COUNCIL ASSESSMENT REPORT

Panel Reference	2016SCL002
DA Number	DA502/2016/1
LGA	Woollahra
Proposed Development	The consolidation of 2 allotments, alterations and additions to the existing heritage listed dwelling-house at 6 Queens Ave, the demolition of an existing dwelling-house at 8 Queens Ave and the construction of a new dwelling to form a horizontally attached (at lower ground floor level) dual occupancy development, swimming pool, landscaping & earthworks
Street Address	6 & 8 Queens Avenue Vaucluse
Applicant/Owner	Mr J & Ms Y Lin
Date of DA lodgement	18/11/2016
Number of Submissions	3
Recommendation	Conditional approval
Regional Development Criteria (Schedule 4A of the EP&A Act)	Cost of works in excess of \$20 million (\$22,093,500)
List of all relevant s79C(1)(a) matters	<ul style="list-style-type: none"> • SEPP (Building Sustainability Index: BASIX) 2004 • SEPP 55-Remediation of Land • SREP (Sydney Harbour Catchment) 2005 • Draft SEPP (Coastal Management) 2016 • Woollahra LEP 2014 • Woollahra DCP 2015 • Woollahra Section 94A Contributions Plan • Clause 92 of the EPA Regulation 2000

DEVELOPMENT APPLICATION ASSESSMENT REPORT

FILE No.	DA502/2016/1
ADDRESS	6 & 8 Queens Avenu

The diagram below indicates the 9.5m height plane. The sections of the building envelope and roof profile of the existing-house located above Council's 9.5m height plane are not proposed to be increased or altered from that as existing.

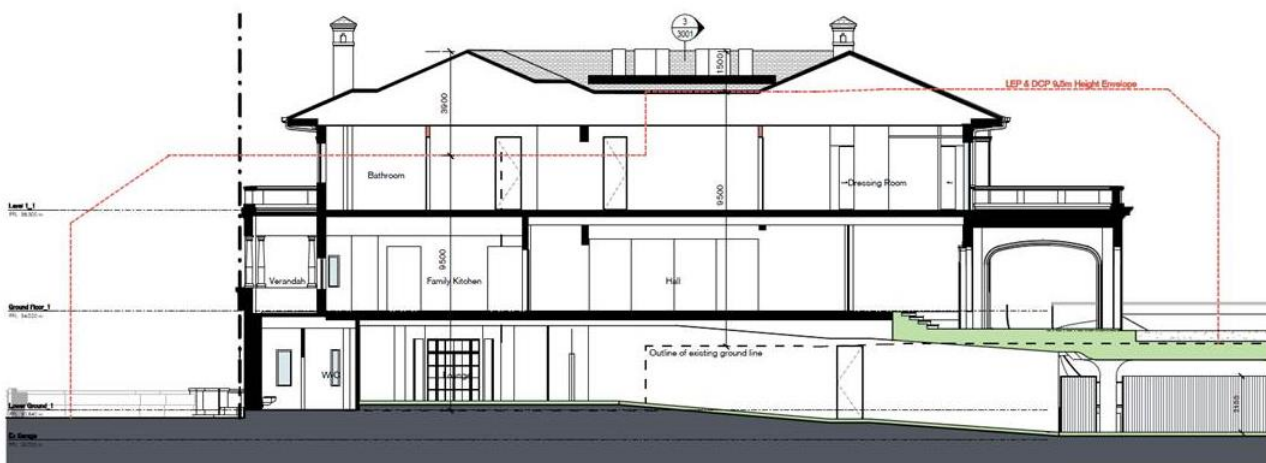
Part 4.3 limits development to a maximum height of 9.5m. The proposal involves a maximum height of 13.5m above existing ground level, a non-compliance of 4m (42%).

The non-compliant aspects of the proposal relate to replacement air-conditioning condensing units to the existing centrally located rooftop mechanical plant deck and internal and external alterations to the upper, southern section of the heritage listed dwelling-house at 6 Queens Avenue associated with the proposed conservation, restoration and adaption works. The subject non-compliant external alterations involve the replacement of existing windows and doors with new metal framed high performance glazing and the addition of a set of double doors to provide access to the western terrace from Bedroom 3 at Level 1.

The sections of the building envelope and roof profile of the existing-house located above Council's 9.5m height plane are not proposed to be increased or altered from that as existing.
